ADDITION &
RENOVATION FOR
BEHRENS RESIDENCE

7506 HIRONDELLE CLUB ROAD
RUXTON, MARYLAND 21204

FIELD CLARIFICATION
THIS DRAWING HAS BEEN PREPARED TO CLARIFY PLAN DIMENSIONS

PARTIAL SECOND FLOOR PLAN
SCALE: 1/4" = 1'-0"

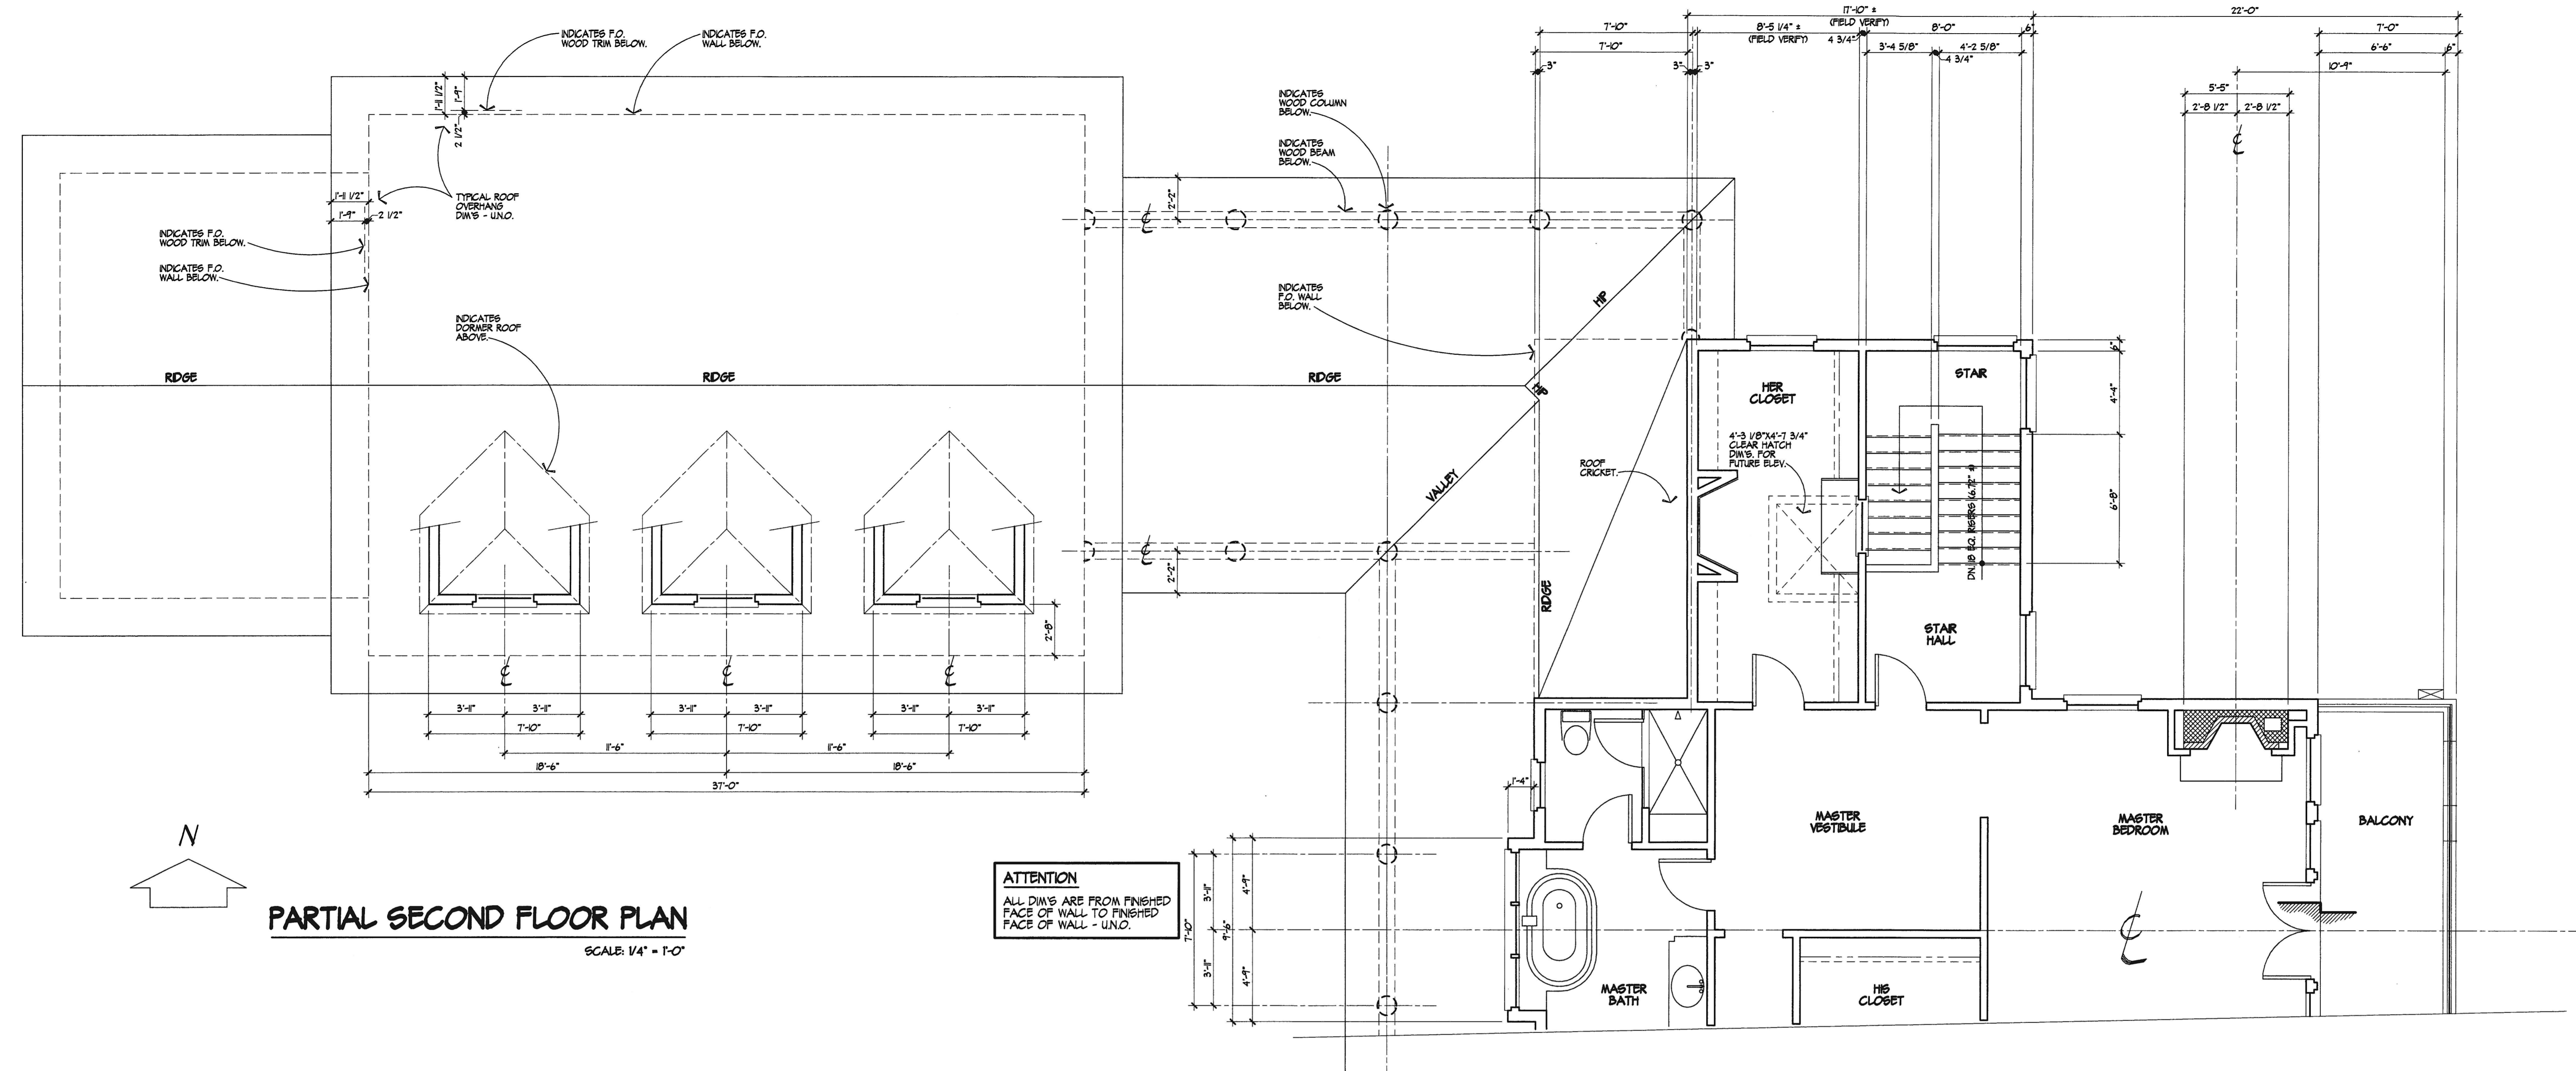
ATTENTION
THIS FIELD CLARIFICATION DRAWING HAS BEEN PREPARED TO CLARIFY PLAN DIMENSIONS ON THE ADDITION'S NORTH SIDE. REFER TO DRAWING #A16 AND A17 FOR ADDITIONAL INFORMATION.

PARTIAL FIRST FLOOR PLAN
SCALE: 1/4" = 1'-0"

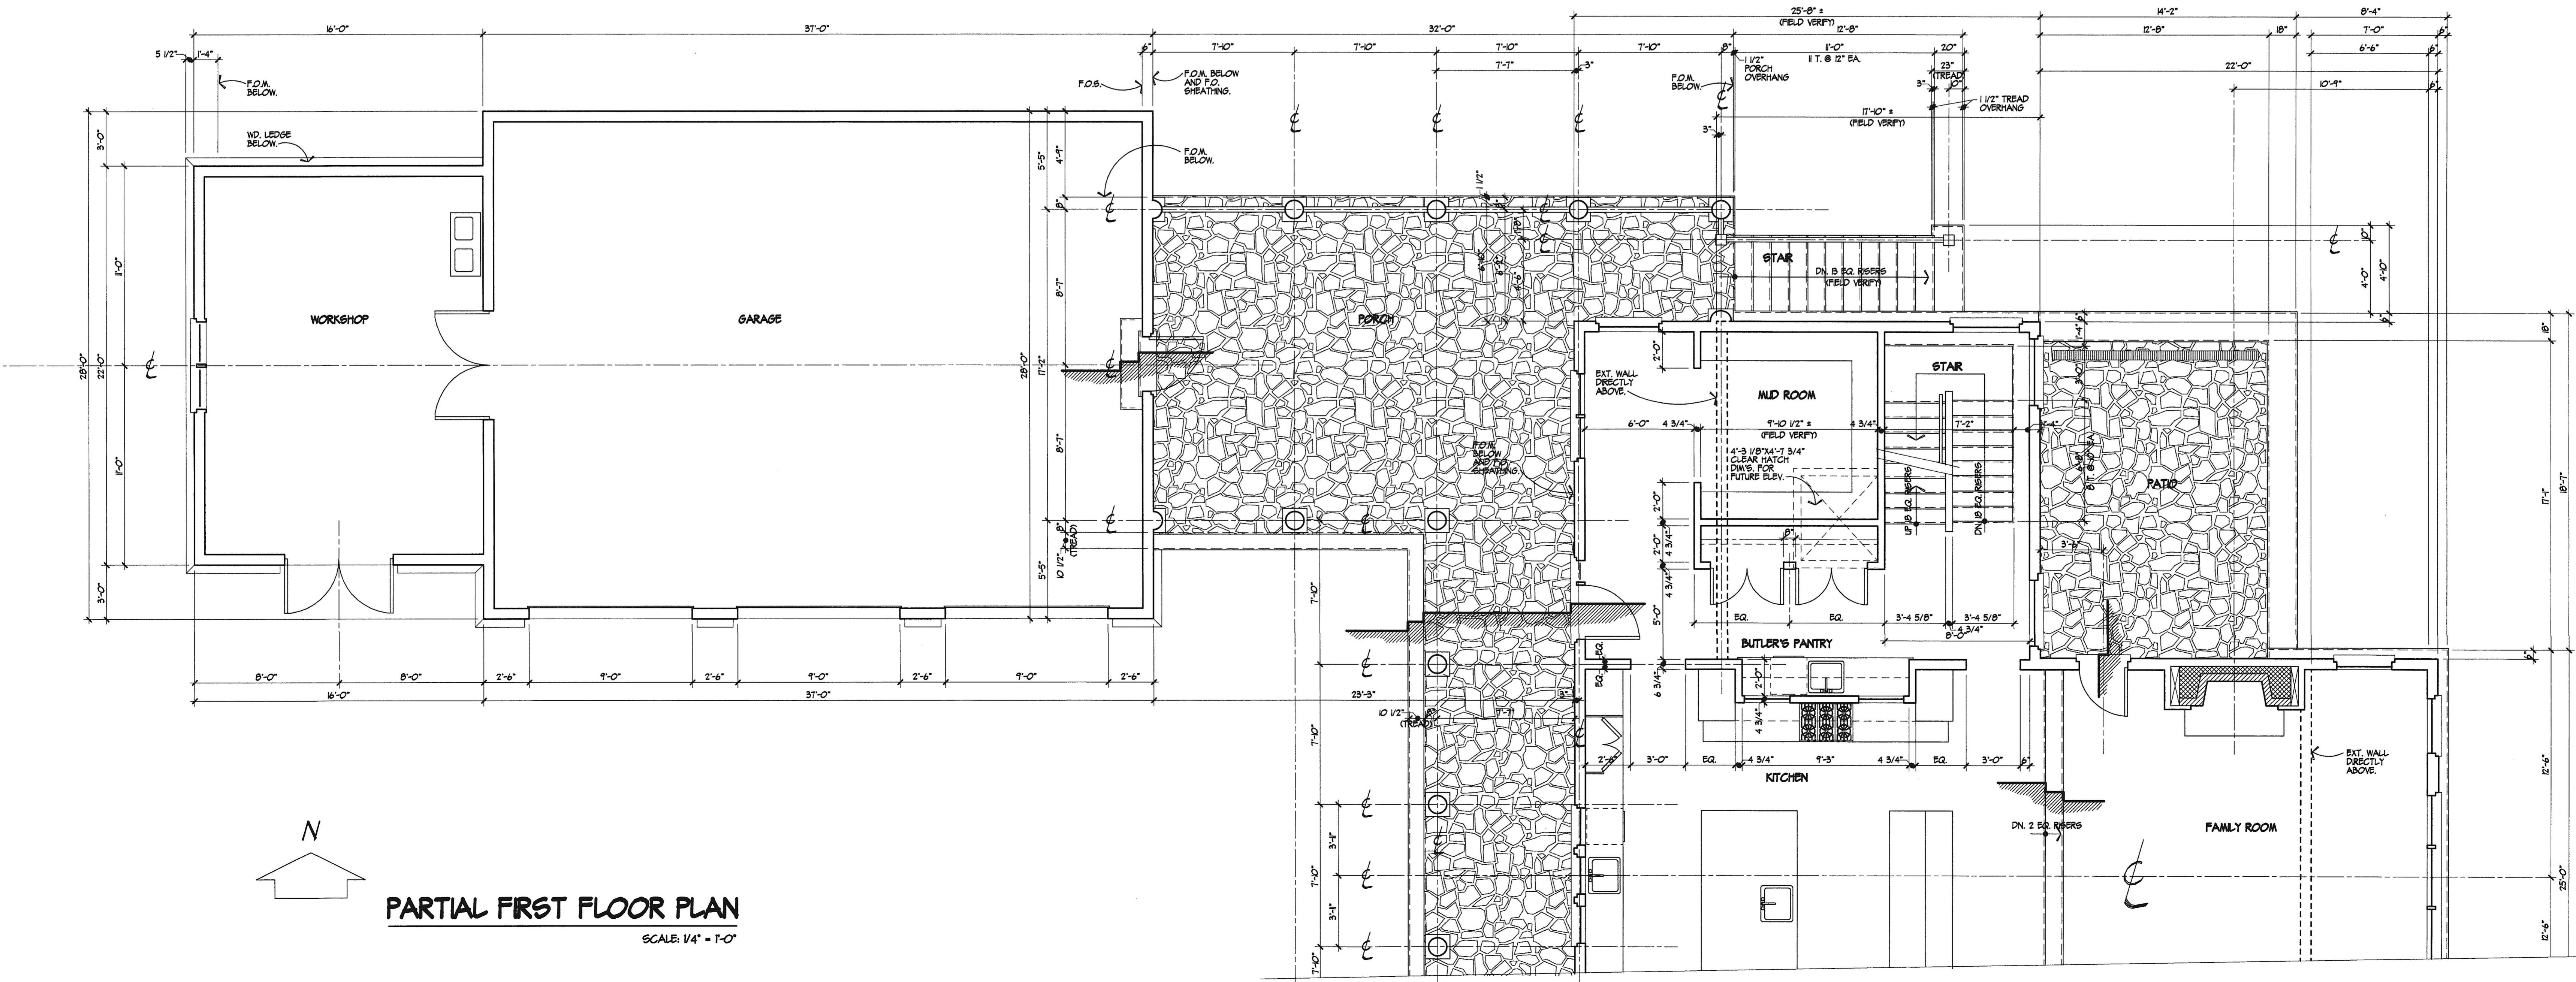
ATTENTION
ALL DIMS ARE FROM FINISHED FACE OF WALL TO FINISHED FACE OF WALL - UNO.
